Contract #: 04-0120F4
 Cty: SF/ALA Rte: 80 PM: 13.2/13.9
 File #: 69.25B

QUALITY ASSURANCE -- NON-CONFORMANCE REPORT

Report No: NCR-000573

Reference Description: MT Indications discovered after ZPMC's NDT testing and acceptance in Segment 7CW

Welding	Concrete	Other	
Welding	Curing	Procedural	Bridge No: 34-0006
Joint fit-up	Coating	Other	Component: Segment 7CW Corner Assembly
Procedural	Procedural	Description: Missed MT indication by QC

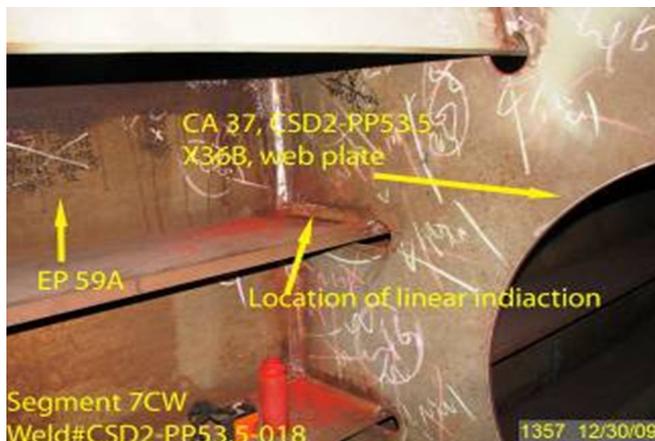
During the Quality Assurance Magnetic Particle Testing (MT) review of welds located on Segment 7CW, this Quality Assurance Inspector (QA) discovered the following issues:

- Two (2) Longitudinal linear indication measuring approximately 20mm and 25mm in length.
- The welds are identified as: CSD3-PP55-025, 026 (30 mm) and CSD2-PP53.5-018 (25 mm).
- The welds are a Fillet Weld type joining the Edge Plate (EP59A) stiffeners to Corner Assembly (CA37A) web plates.
- The OBG 7CW segment is located at in front of Blast Shop.

The Notice of Witness Inspection Number (NWIT) is 004947. The indication is located inside the area that has been previously tested and accepted by ZPMC Quality Control (QC) personnel. ZPMC's QC personnel are required to perform twenty five (25%) percent MT inspection of this weld.

Submit a repair procedure to the engineer for approval. Provide the ZPMC MT technician additional training and equipment to ensure these types of indications are identified in the future.

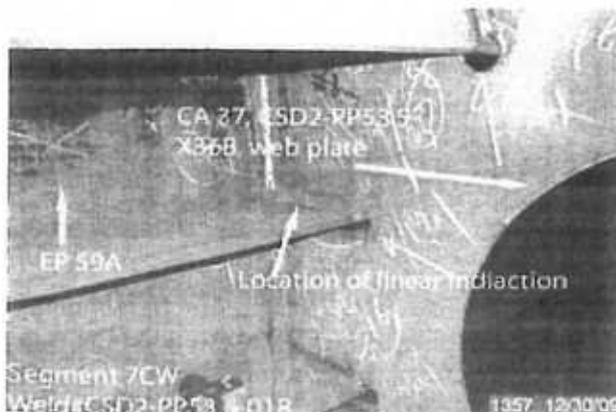
During the Quality Assurance Magnetic Particle Testing (MT) review of welds located on Segment 7CW, this Quality Assurance Inspector (QA) discovered the following issues:

- Two (2) Longitudinal linear indication measuring approximately 20mm and 25mm in length.
- The welds are identified as: CSD3-PP55-025, 026 (30 mm) and CSD2-PP53.5-018 (25 mm).
- The welds are a Fillet Weld type joining the Edge Plate (EP59A) stiffeners to Corner Assembly (CA37A) web plates.
- The OBG 7CW segment is located at in front of Blast Shop.

The Notice of Witness Inspection Number (NWIT) is 004947. The indication is located inside the area that has been previously tested and accepted by ZPMC Quality Control (QC) personnel. ZPMC's QC personnel are required to perform twenty five (25%) percent MT inspection of this weld.

Reference Description: Missed UT indications by QC on Segment 9DE: Edge Plate to Deck Plate weld and Edge Plate Stiffener to FL3 weld

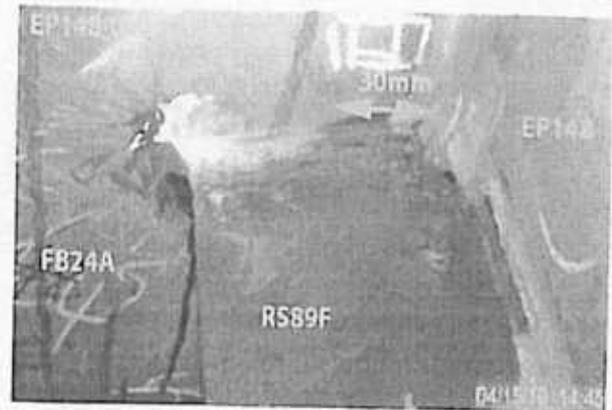
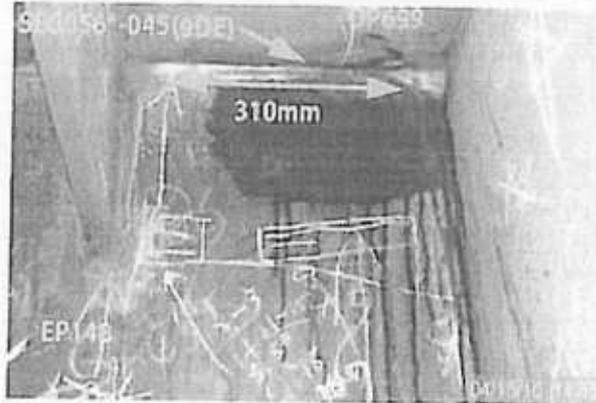
During the Quality Assurance (QA) Ultrasonic Testing (UT) review of welds located on Orthotropic Box Girder (OBG) Segment 9DE, this QA Inspector discovered the following issues:

- Two (2) longitudinal linear indications measuring approximately 310mm and 30mm in length.
- The indications dBs rating are +6 and +4.
- Material thickness is 18mm.
- The depth of the indications is approximately 11mm and 13mm.
- The welds are identified as SEG056*-045 at Panel Point (PP) PP81.5 and EP148-022 at PP 81.
- The welds are designated as Seismic Performance Critical Material (SPCM).
- The indications are clearly marked on or near the weld.
- The Y distance for the indications are 50 mm from PP81.5 and 0 mm from EP148A.
- Weld SEG056*-045 is a Complete Joint Penetration (CJP) Corner joint, joining the Edge Plate PL1336C (SPCM) to Deck Plate PL1314A (Non SPCM).
- Weld EP148-022 is a Complete Joint Penetration (CJP) "T" joint, joining the Edge Plate stiffener RS89F (Non SPCM) to FB24A plate PLX24D (SPCM).
- Segment 9DE is located outside of Paint shop.

The Notice of Witness Inspection (NWIT) No. is 005523. The indication is located in an area previously tested and accepted by ZPMC Quality Control (QC) personnel. As per the contract documents, ZPMC's QC personnel are required to perform hundred (100%) percent UT inspection of this weld.

AWS D1.5-02 Section 6; Table 6.3 specifies a class "A" indication as having a rating of 10dBs and under for material thicknesses 8mm through 20mm.

Reference Description: QC Missed 2 MT Transverse Indications on Segment 9EE U-Rib Deck Diaphragm welds

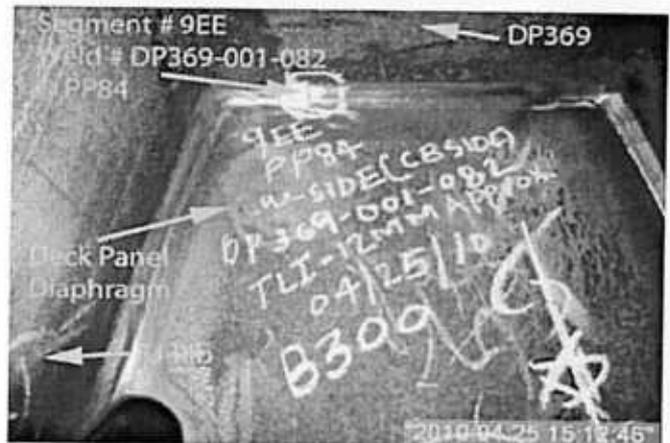
-One (1) Transverse linear indication measuring approximately 10 mm in length.

-Weld is a Complete Joint Penetration (CJP) Weld joining the Deck panel Diaphragm to U-Rib.

-Weld Identification number is DP477-001-137 @ Panel Point-083.

-Deck panel Diaphragm is identified as X1E.

-U-Rib is Identified as R18D.

-Location Panel Point (PP83).

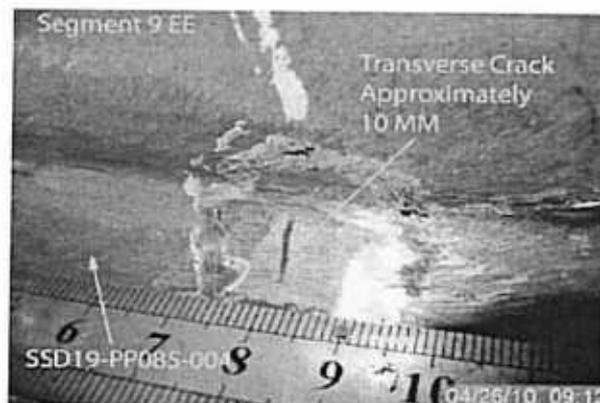
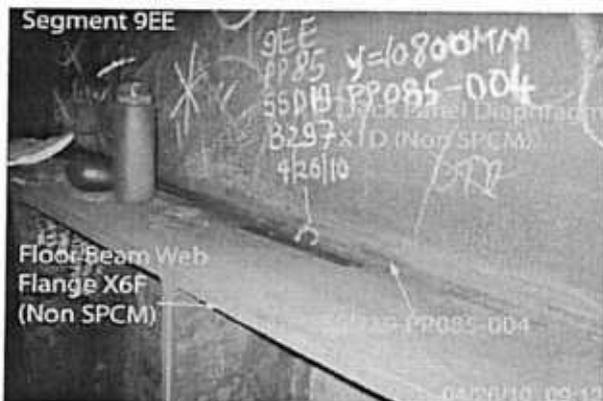
During the Quality Assurance (QA) Magnetic Particle Testing (MT) review of welds located on Segment 9EE, this QA Inspector discovered the following issues:

- One (1) transverse crack measuring approximately 10mm in length in the fillet weld joining the Deck Panel Diaphragm (X1D) to Floor Beam Web Flange (X6F) at panel point 85.
- The Y location is 10800mm from the termination of the weld on the crossbeam side.
- The indication is clearly marked near the weld.
- The weld is identified as: SSD19-PP085-004.
- OBG segment 9EE is located north of the blast shop.
- The Notice of Witness Inspection Number (NWIT) is 005583. The indication is located within the area that has been previously tested and accepted by ZPMC Quality Control (QC) personnel.
